MONTGOMERY COUNTY PLANNING DEPARTMENT

MEMORANDUM

PROJECT NAME: Hallman Grove

CASE NO. 120073050

SK-1

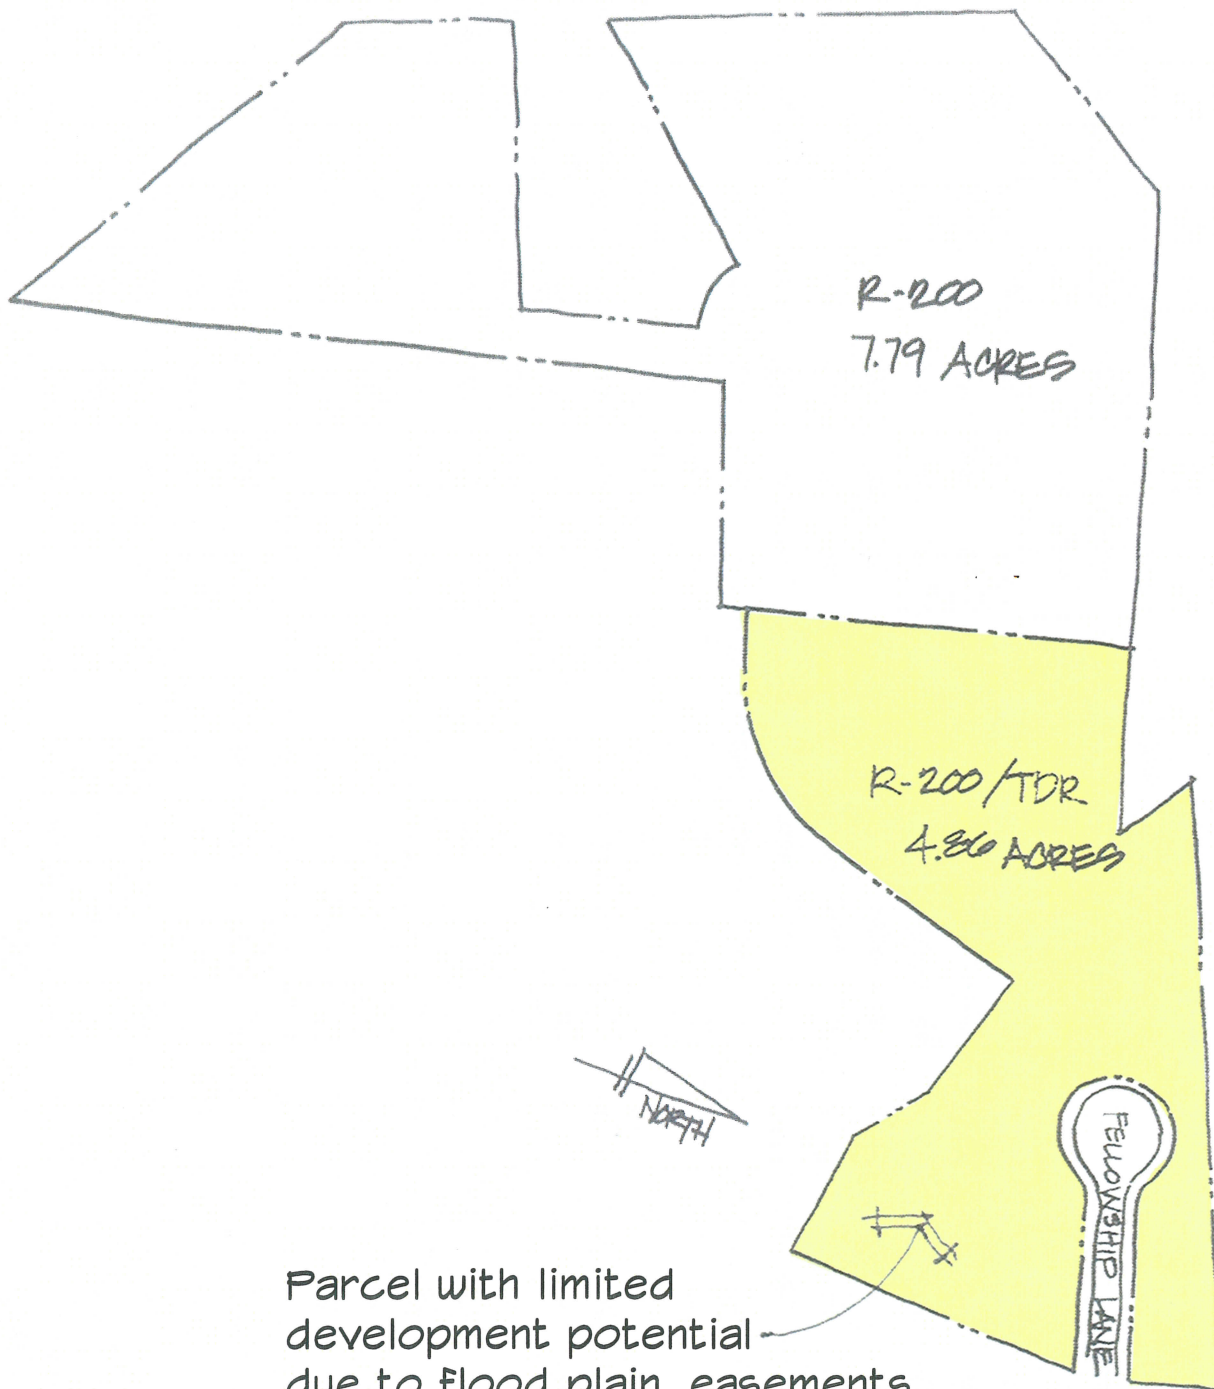
The portion of the parcel located in the R-200 TDR-3 zone is 4.86 acres (Sketch SK-1). Using the tabular density from 59-C-1.62, the developer has proposed a density contribution of 11 dwelling units for this component area of the combined tract. Using the MPDU development criteria of Section 59-C-1.6, 11 dwelling units can not be developed on this component area of the combined tract due to significant restrictions imposed by the following:

Parcel with limited development potential due to flood plain, easements, stream buffers and setbacks

SK-2

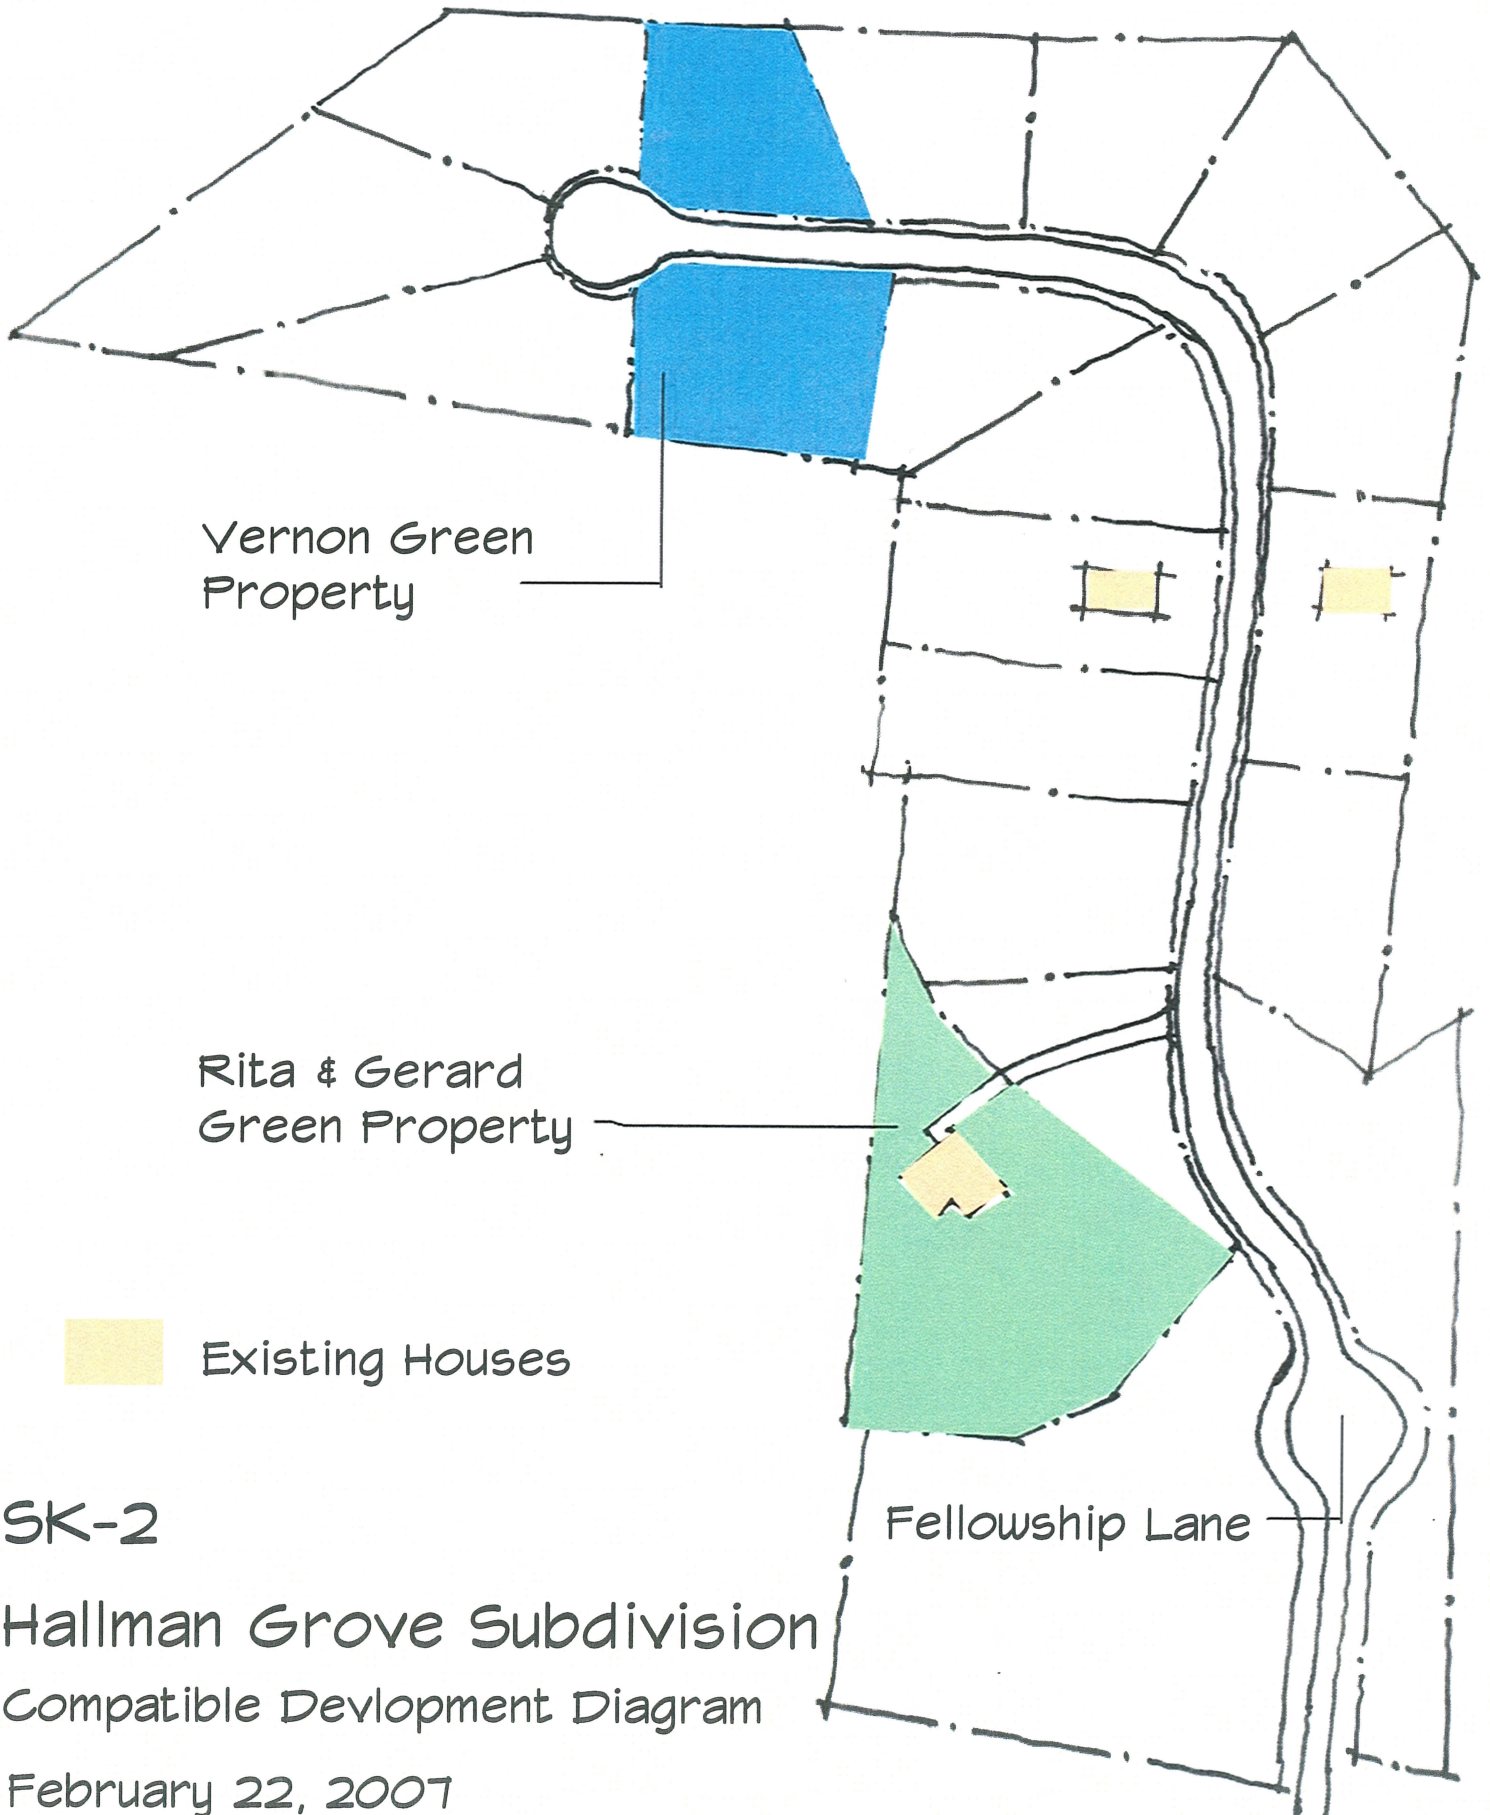
Allowing the developer to utilize the tabular density on the TDR-3 portion of this site has resulted in a solution which is incompatible with the surrounding communities. The following are the most significant aspects of the proposed solution's incompatibility:

- The proposed development plan has significantly smaller lot sizes than any of the surrounding communities. Existing lot sizes on Fellowship Lane are over 20,000 SF and the immediate neighbors that are not part of the proposed development have lot sizes that exceed 40,000 SF.
- The public road extension and private drive that provide access to the houses in the development have been located behind the rear lot line of the adjacent community of Quince Orchard Estates with a narrow
